**AGENDA**  
**CITY OF CEDAR FALLS, IOWA**  
**PLANNING AND ZONING COMMISSION**  
**WEDNESDAY, JULY 25, 2018**  
**5:30 PM AT CITY HALL - COUNCIL CHAMBERS**

TO: Planning and Zoning Commission
FROM: David Sturch, Planner III
DATE: July 18, 2018
SUBJECT: Highway 1 District Site Plan Review – Raising Cane’s

TO: Planning & Zoning Commission
FROM: David Sturch, Planner III
DATE: July 18, 2018
SUBJECT: Redevelopment of 6607 University Avenue

PRELIMINARY CONCEPT SITE PLAN

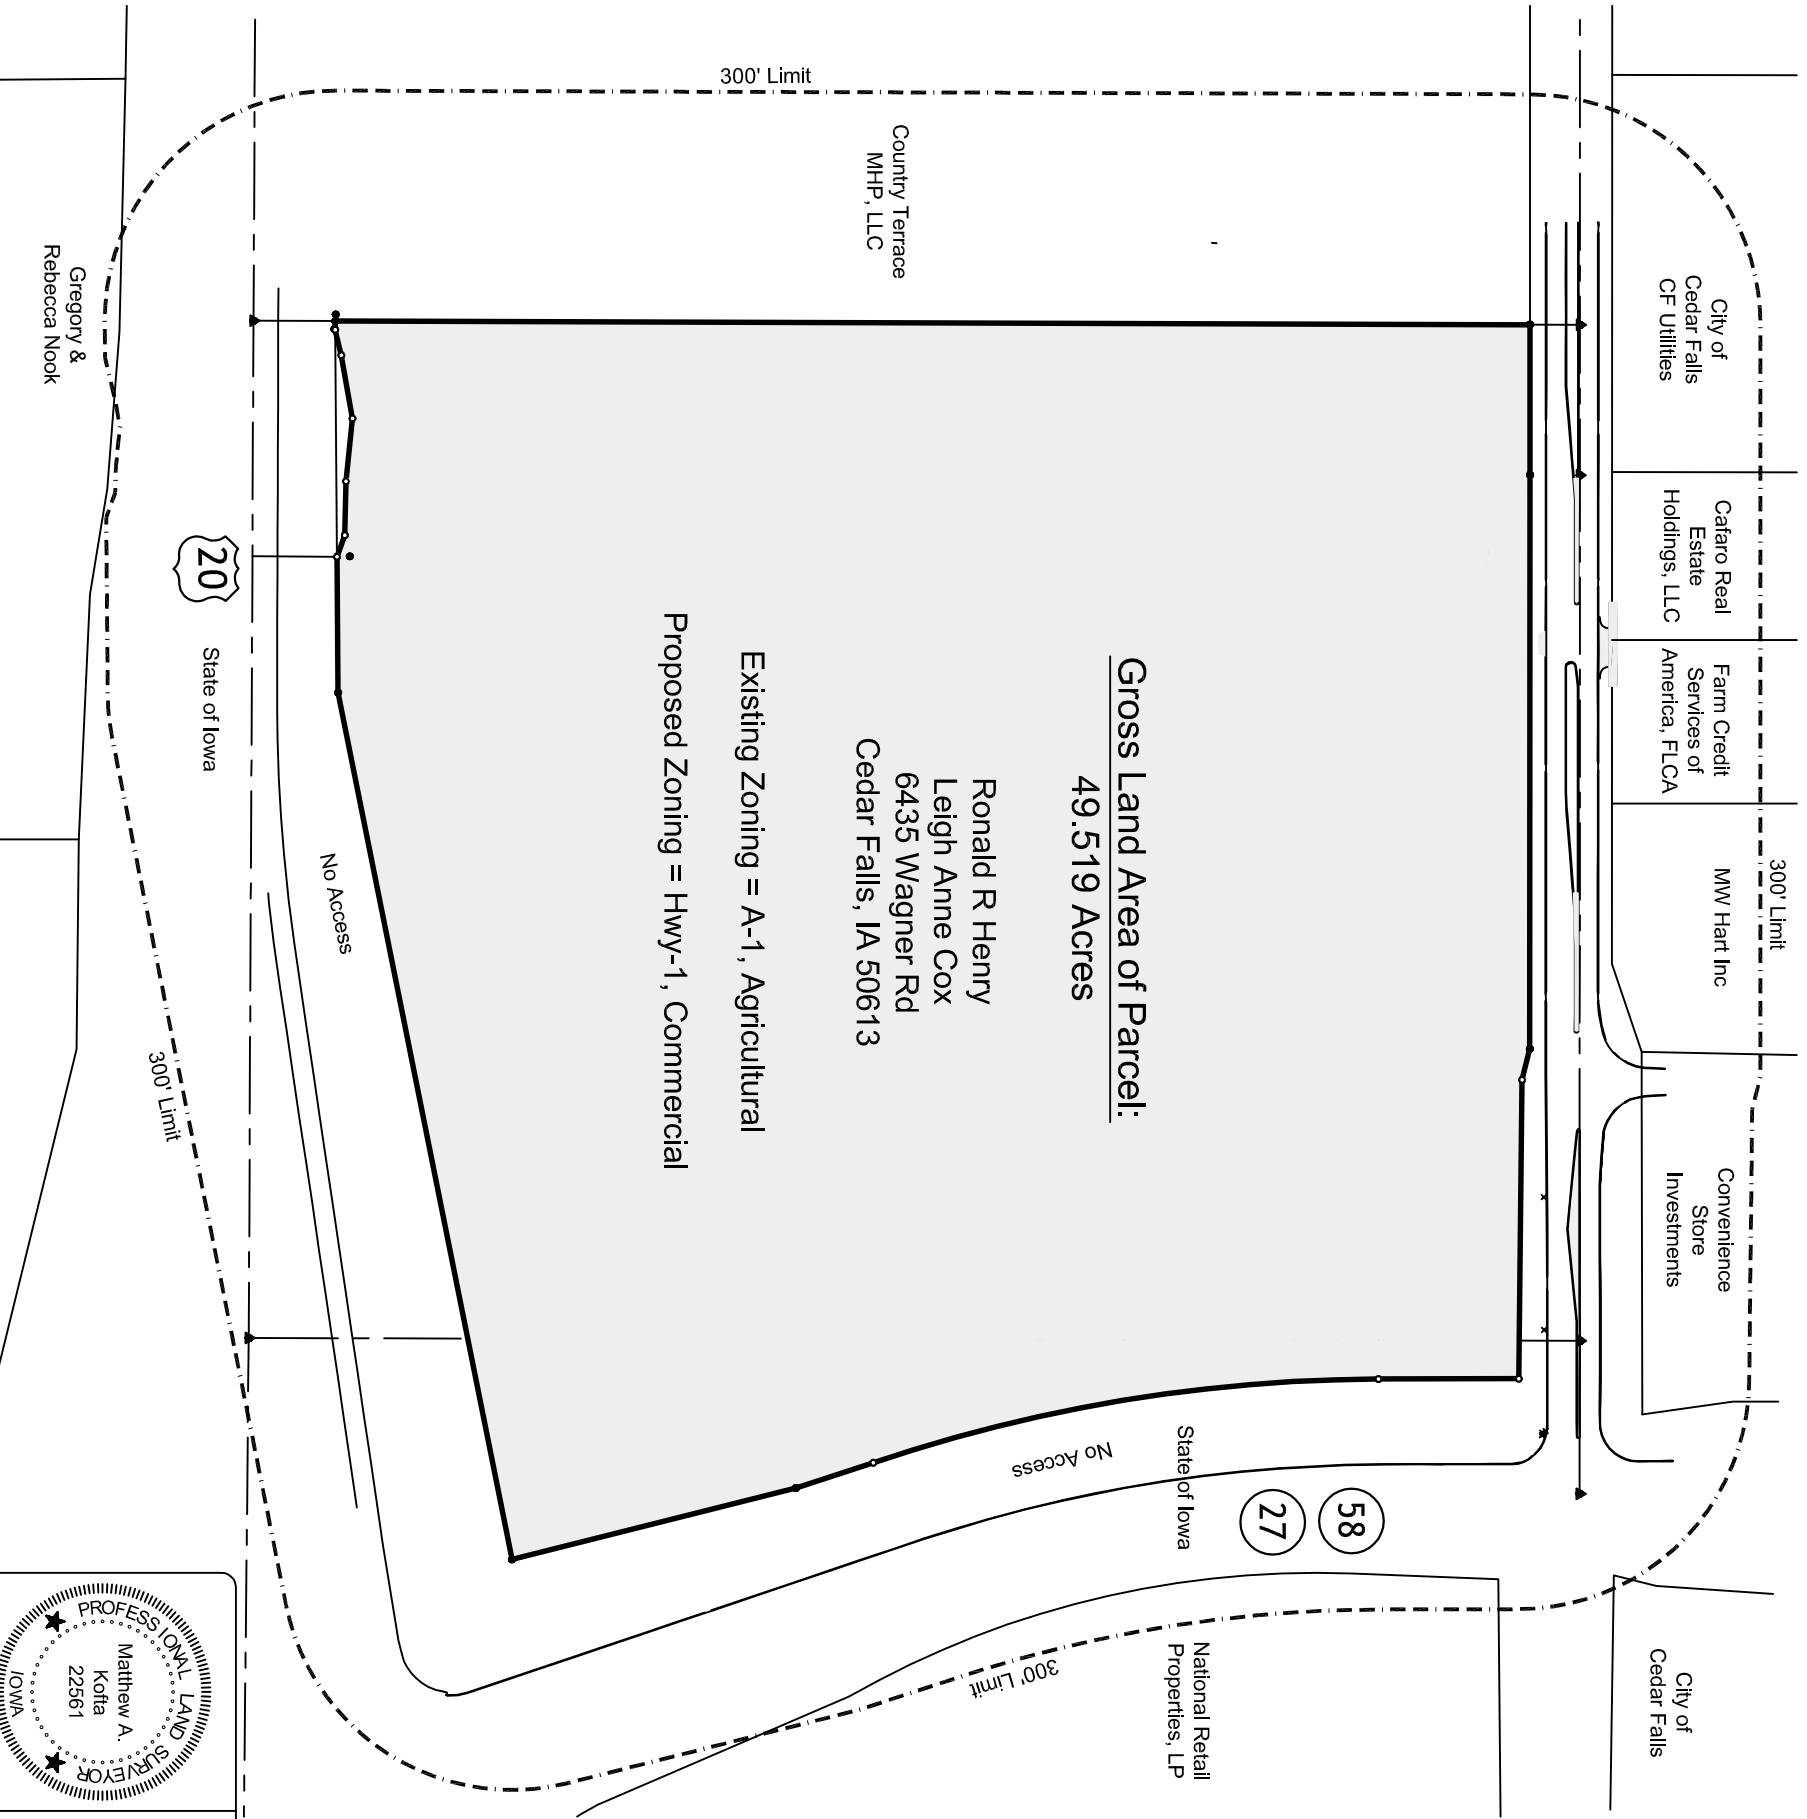
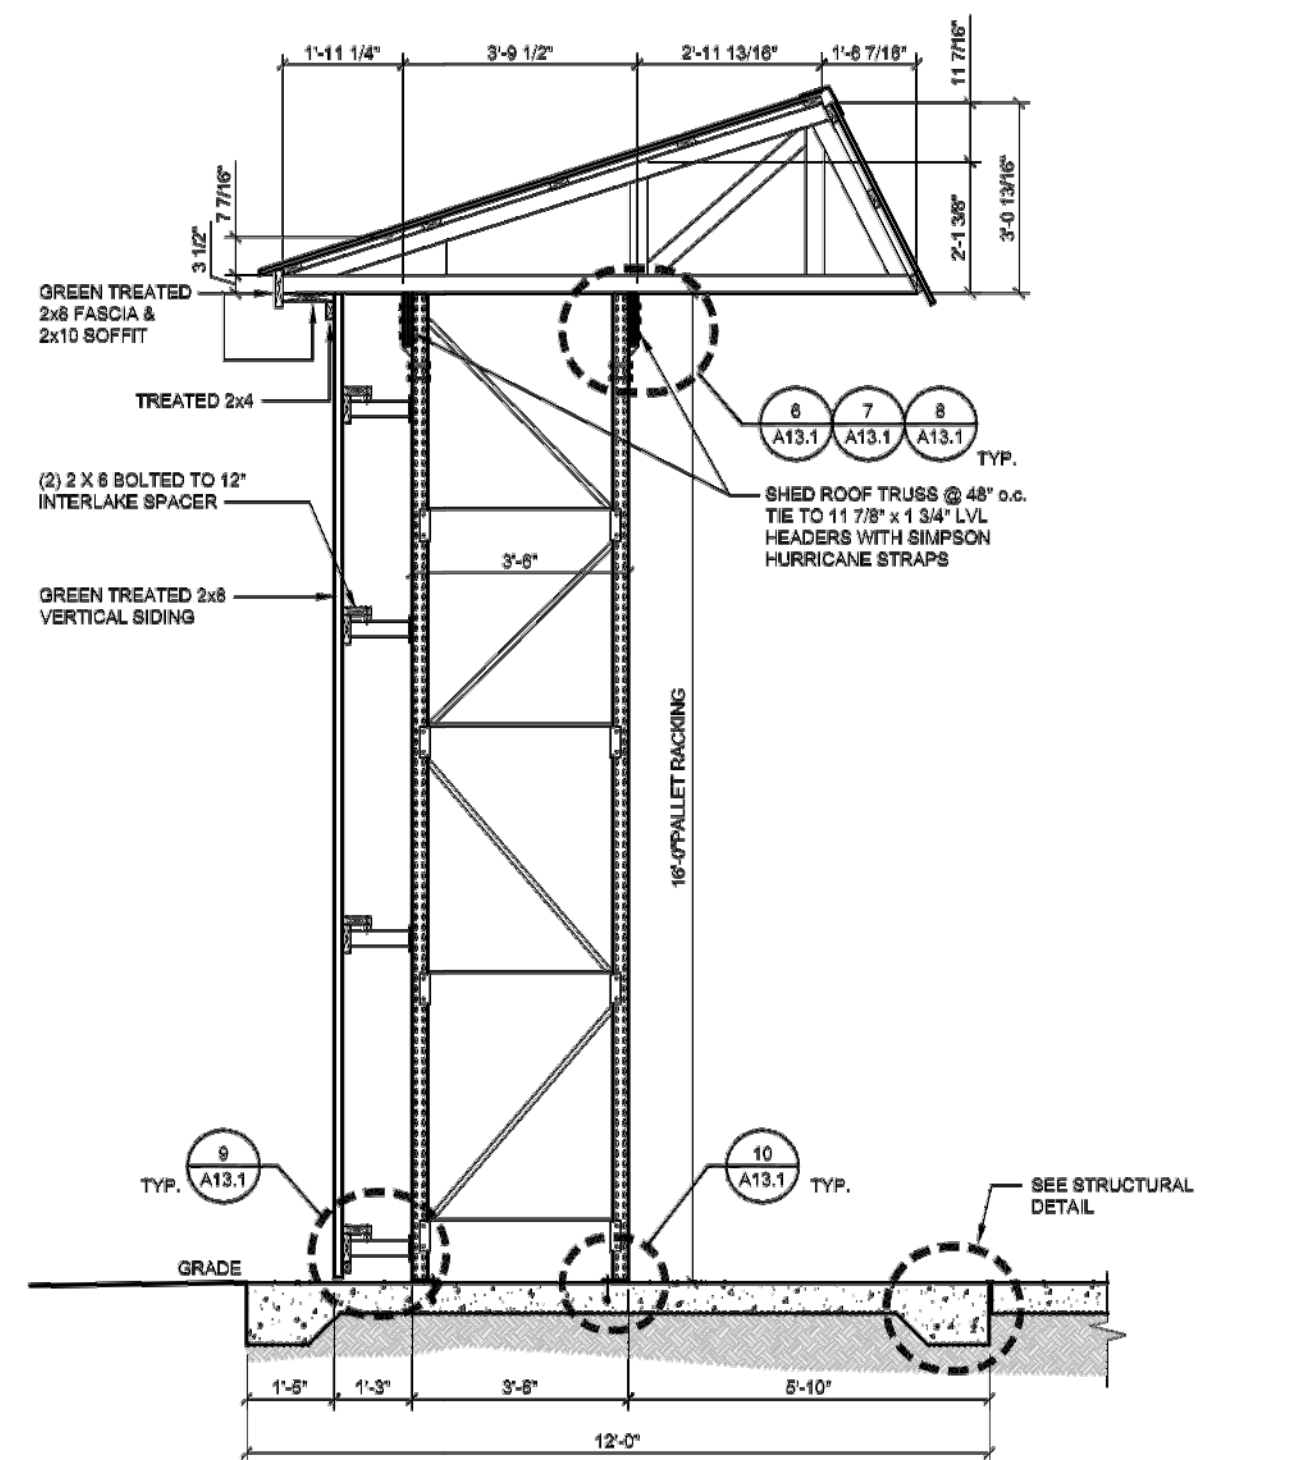
At the Planning & Zoning Commission meeting held on July 11, 2018, staff recommended that the discussion be continued to allow staff time to analyze any potential conditions that may be warranted as part of the zoning approval, given that the traffic study had not yet been submitted for review. The traffic study recommendations will inform the improvements necessary to warrant the upzoning from agricultural zoning to commercial zoning. Since the traffic study has not been submitted, detailed recommended conditions will not be available at this time, however a general condition can be included that references any needed improvements that the study recommends. In addition to a condition regarding traffic improvements, staff would propose several other conditions as noted below:

1. All street, intersection, and traffic control improvements necessary to provide for safe and efficient traffic control and circulation to serve the long term needs of the subject development at full build out without causing undue traffic circulation and congestion problems for other development in the corridor must be constructed and accepted by the City prior to issuance of an occupancy permit and shall be at the expense of the developer.

2. The area shown as “*Future R/W (right of way)*” on the concept site plan shall remain as open space and shall not be developed with any structures, fences, buildings, hard surfacing, driveways or sidewalks.

4. A 5-foot wide sidewalk shall be installed along the entire street frontage along W Ridgeway Avenue.
5. Sidewalks shall be installed throughout the interior of the development site to provide pedestrian connections/accommodations to each of the commercial buildings/properties within the development.
